## City Hall

## City of Everett ADA Transition Plan

March 2018

Institute for Human Centered Design

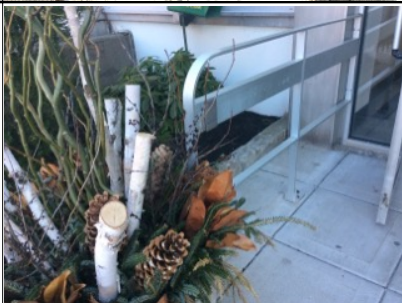
ID	Location	Element	Type	Photo	Issues	Current Measure	Recommendations	Quantity	Price	Cost Estimation
E5	Broadway and Webster St.	Detectable Warnings	Perpendicular		Detectable warnings not provided	-	Provide a detectable warning on curb ramp on opposite side.	1	180	\$180
<b>Street Furniture</b>										
<b>Benches &amp; Seating</b>										
E6	Broadway and Church St.	Benches & Seating	N/A		Clear floor space adjacent to the bench not provided	-	Provide a 30" x 48" clear space adjacent to the bench. Relocate trash can.	1	Labor	\$0
<b>Universal Design</b>										
E7	Church St. Accessible Entrance						Universal design recommendation - provide a curb cut at front of accessible space.	1	1225	\$1225

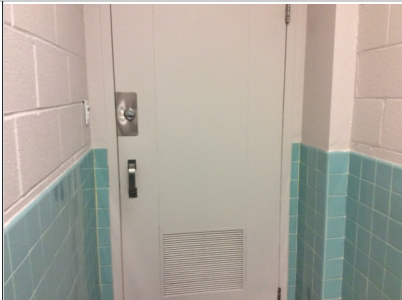
ID	Location	Floor	Room	Element	Type	Photo	Issues	Current Measure	Recommendations	Quantity	Price	Cost Estimation
6	Parking Lot (Car Accessible Space)	Ext		Off-Street Parking Lot or Garage	Visitor		Sign < 60" above finished grade	56:5"	Locate sign with the bottom of the sign 60" above the ground.	1	Labor	\$0
<b>Entrance</b>												
7	Front Entrance	1		Entrance	Main Entrance		Neither door leaf is compliant Door requires >15 lbs. of force to open	26.5" 17 lbs	Provide automatic door openers for both doors in each set of double doors at this entrance/exit.	2	1530	\$3060
8	Accessible Entrance by Room 1	LL	1	Entrance	Main Entrance		Surface not stable, firm, and slip-resistant at entrance		Repair surface.	1	103 / Labor	\$103
9	Parking Lot Entrance	Ext		Entrance	Secondary Entrance		Clear floor space at opener not provided		Provide a 30" x 48" clear floor space at automatic door opener. Relocate planter. Consider providing additional contrast at button so that it's more visible.	1	Labor	\$0

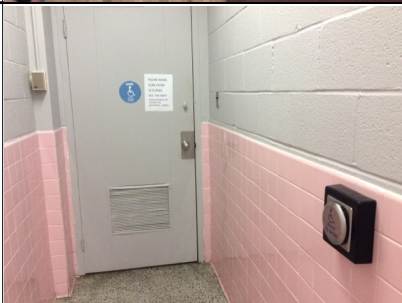
<b>Interior Access Route</b>												
14	Retirement Office	3	30	Interior Access Route	N/A		Route < 36" wide	28"	Ensure that a clear width of 36" min. is maintained at the accessible route.	1	Labor	\$0
15	Corridor by Elevator	1		Interior Access Route	N/A		Obstructed by protruding objects	7.5"	Provide a cane detectable barrier at AED.	1	153	\$153

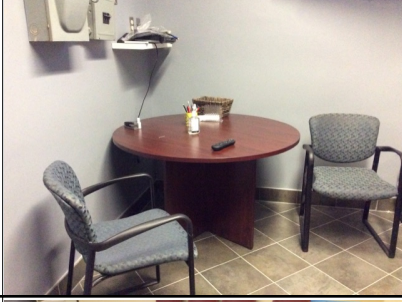
<b>Service Counter</b>												
55	Information Counter	1		Service Counter	N/A		Counter > 36" high	42"	Provide a counter that is 36" max. above the ground or finish floor.	1	440	\$440
